ERRATA

Illinois Route 47 (Reed Road to U.S. Route 14) McHenry County, Illinois

Job No. P-91-101-07

August 10, 2016

\\uschi\fs001\prod\Projects\P60039027\000_CAD\006_Civil\Env\Sheets\39027_SHT_ENV_Constraints06.dgn 7/8/2016

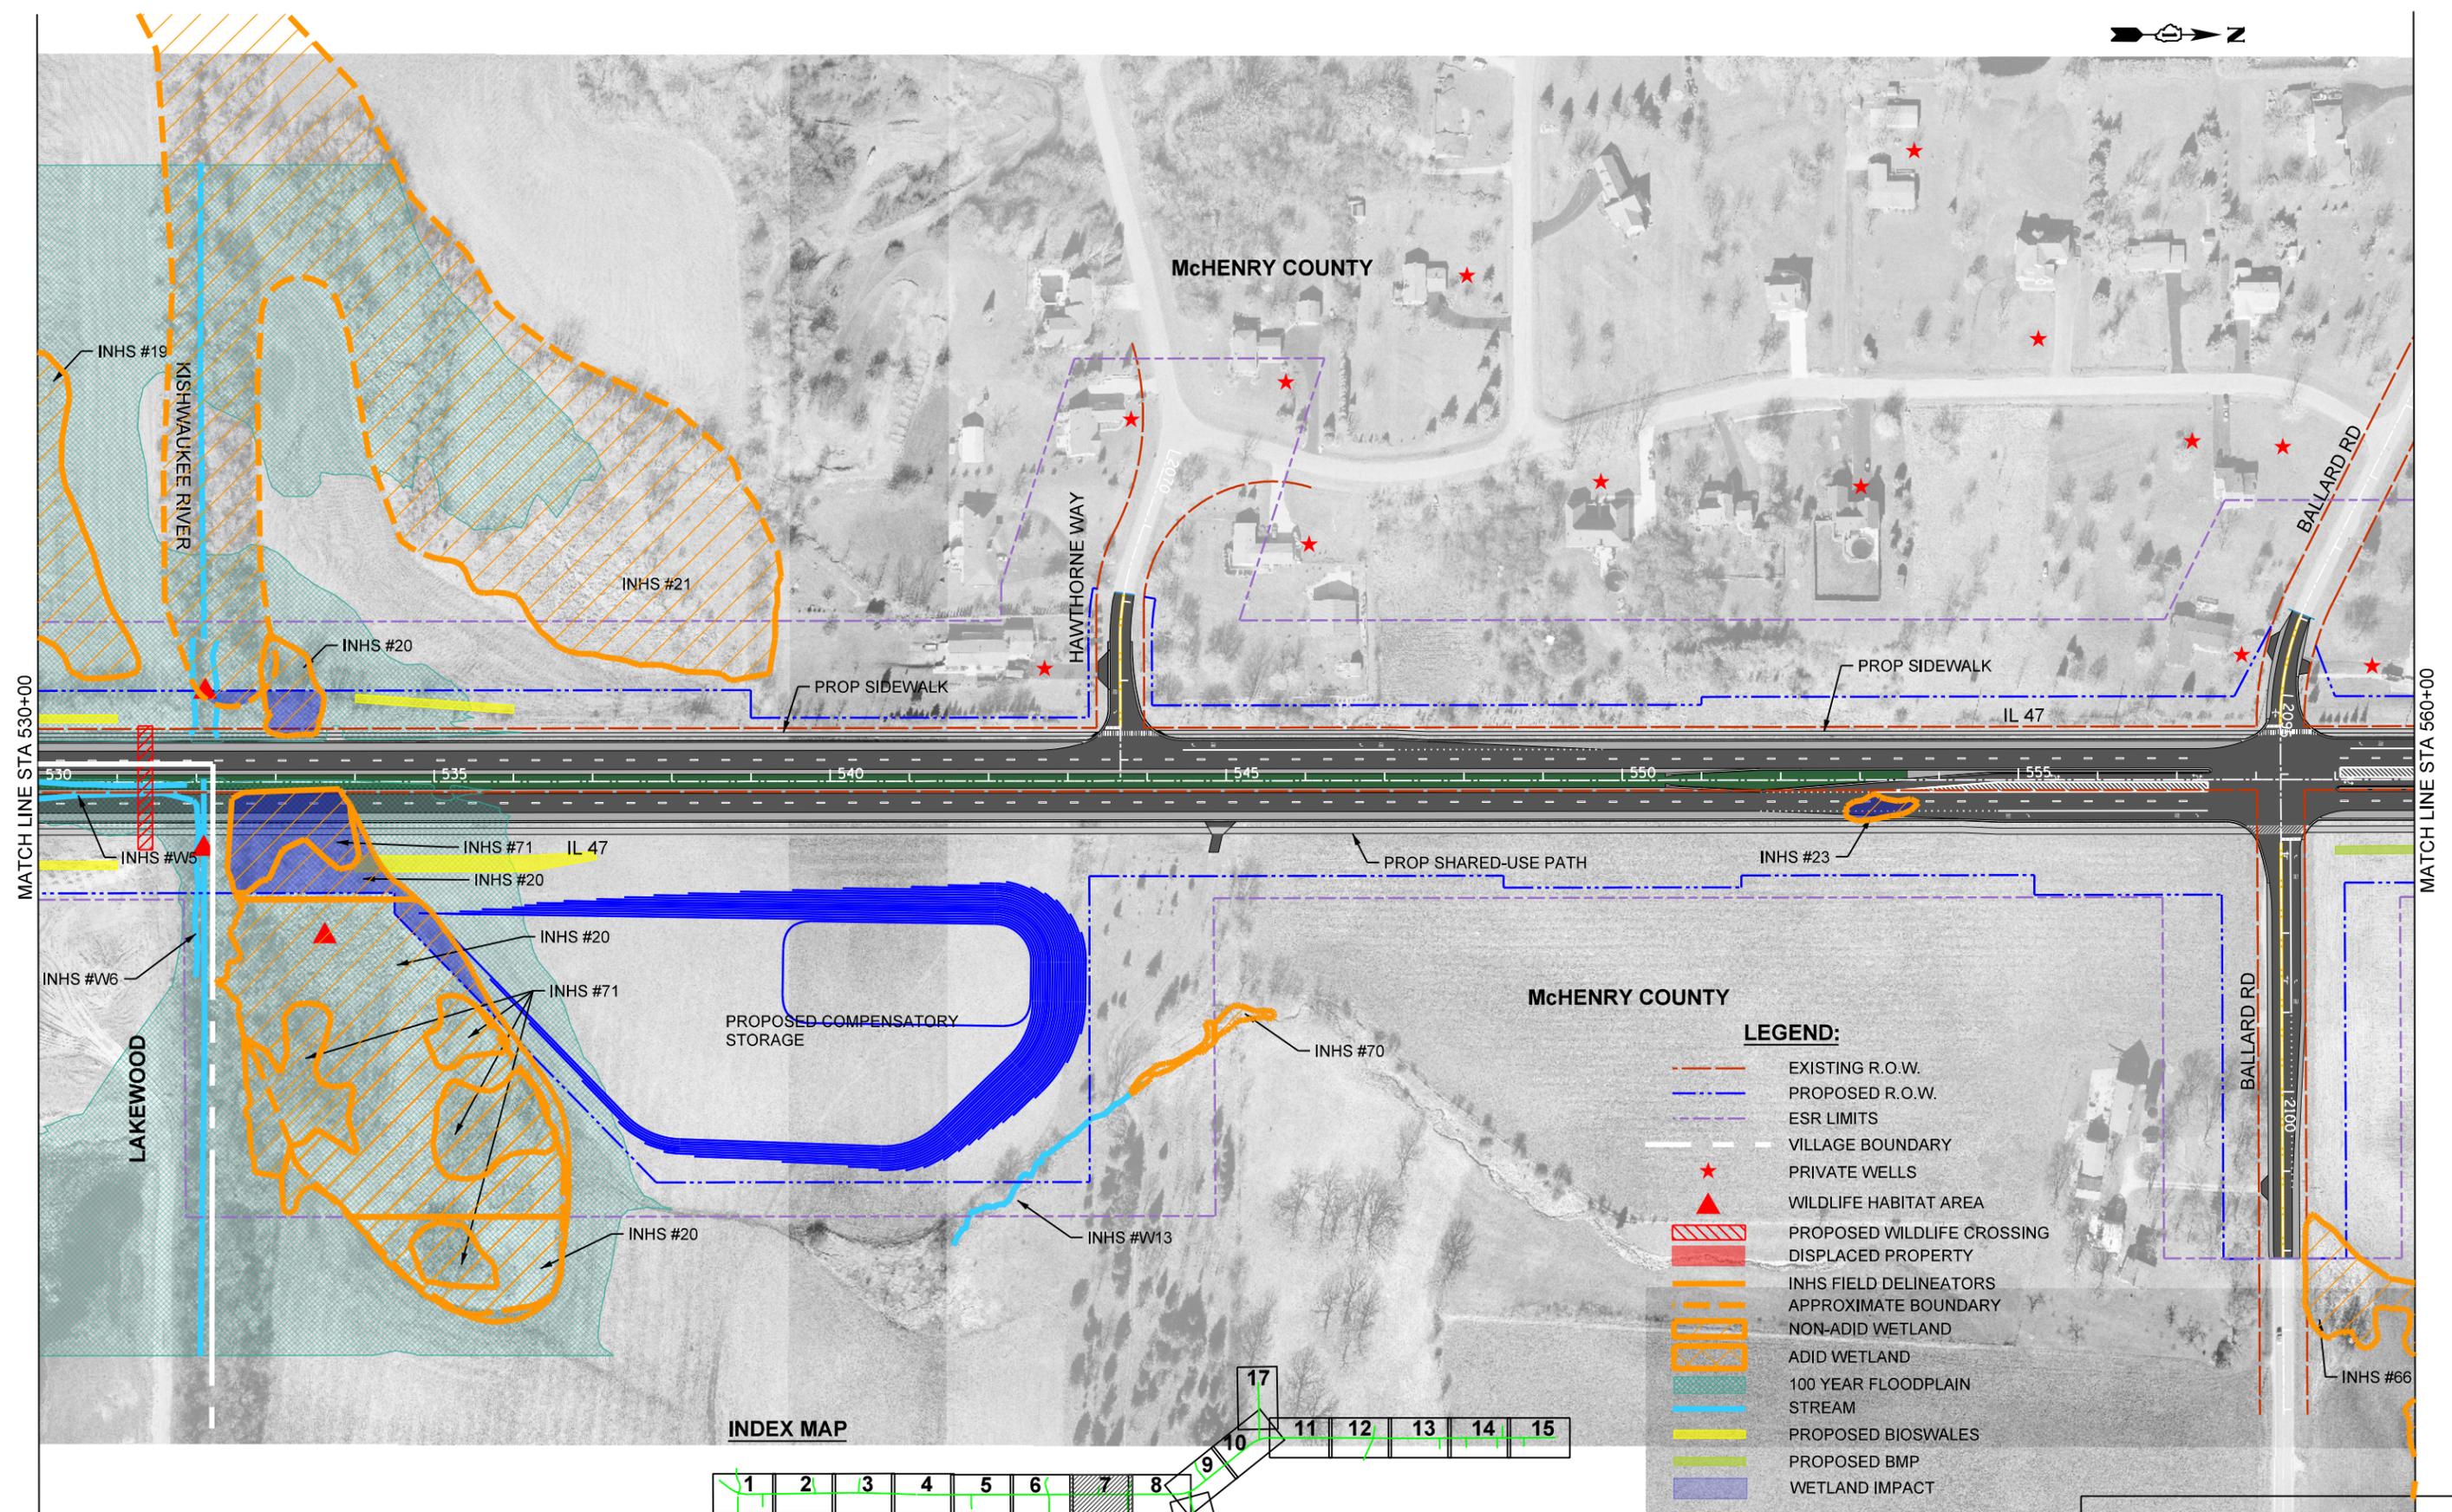
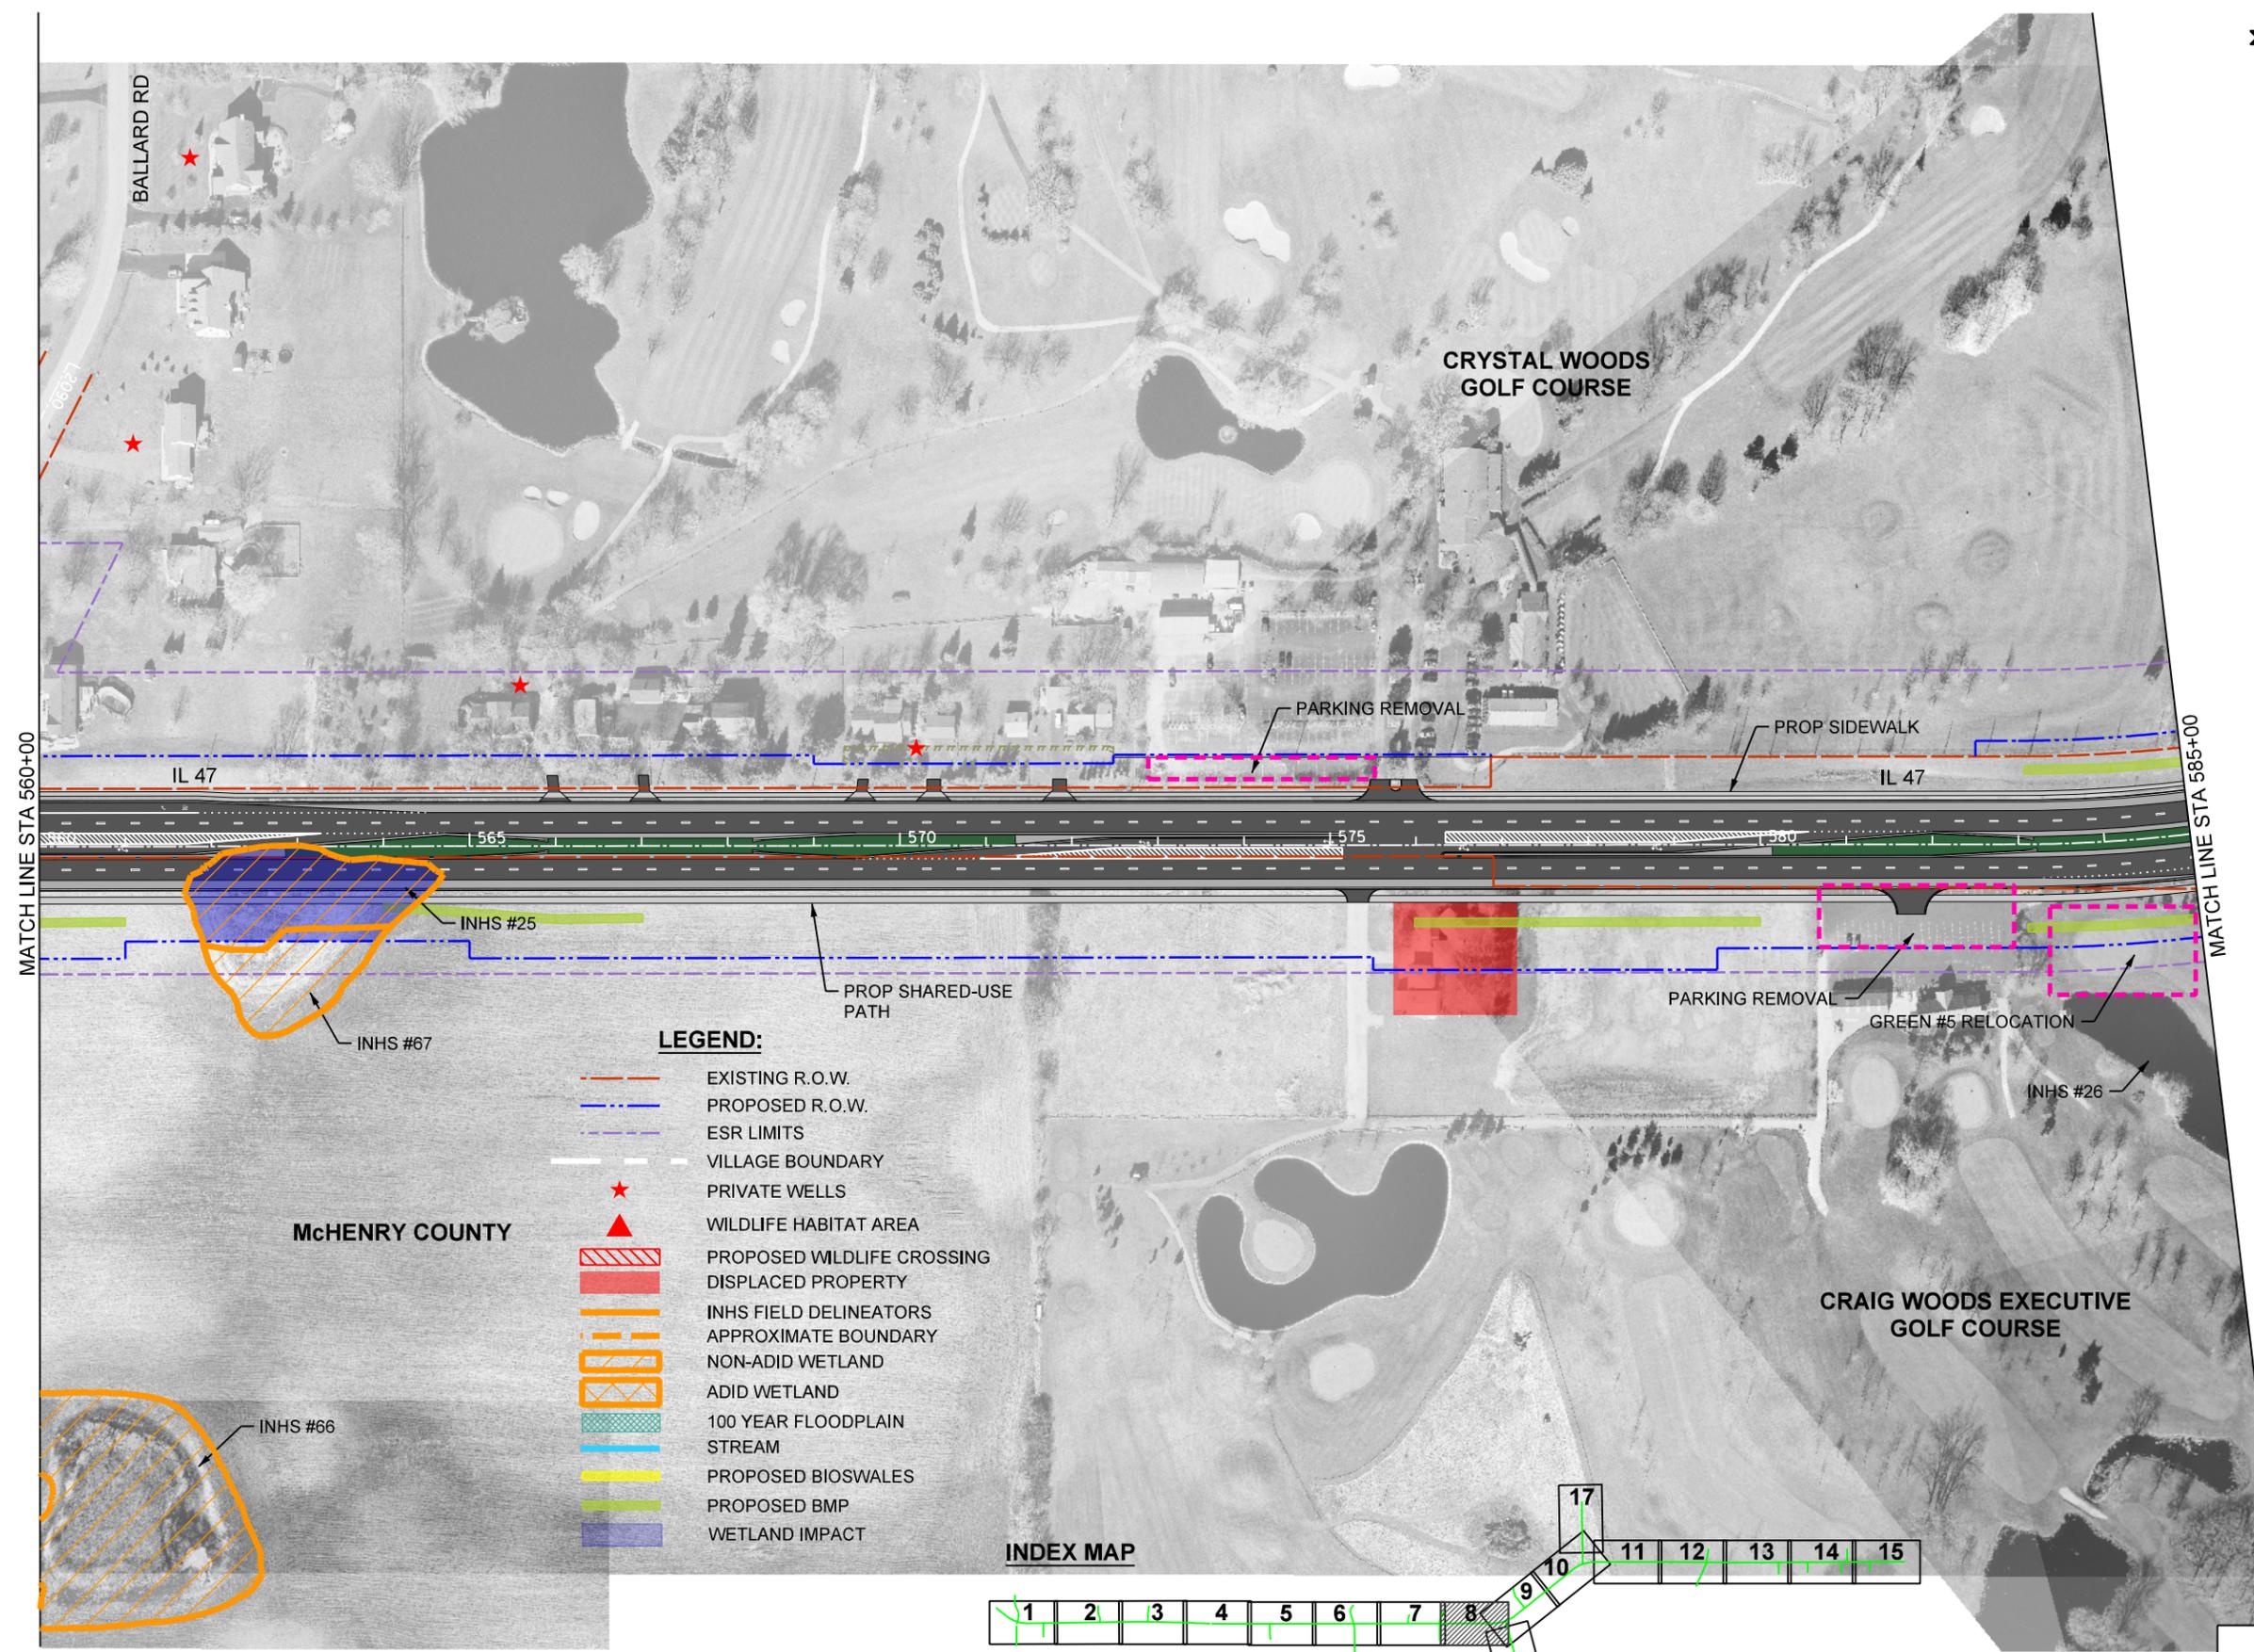
Replace Exhibit 4-1 Environmental Constraints Map to show updates to waterway names to be consistent with the Environmental Assessment, revised symbolization of the bioswales and inclusion of additional BMPs.

R	<p>A revised exhibit with a non-conflicting color scheme has been included in the Errata.</p>
87	U.S. Army Corps of Engineers	C	<p>The bioswale locations in Exhibit 4-1 should not be located within delineated wetlands or streams. Exhibit 4-1 should be revised accordingly for the final EA;</p>
		R	<p>The exhibit has been revised showing potential new locations as necessary. However, since the wetland impacts were considered to be everything within the ROW, those areas are proposed ditch locations where BMPs or bioswales are proposed; there may no longer be a functioning wetland due to construction disturbance. The design engineers will consider where regrading for the roadway and ditch work will take place while minimizing any impacts. However, there will be situations where the wetland will be graded out as part of the roadway and/or ditch construction, but these locations may be replaced with a bioswale.</p>
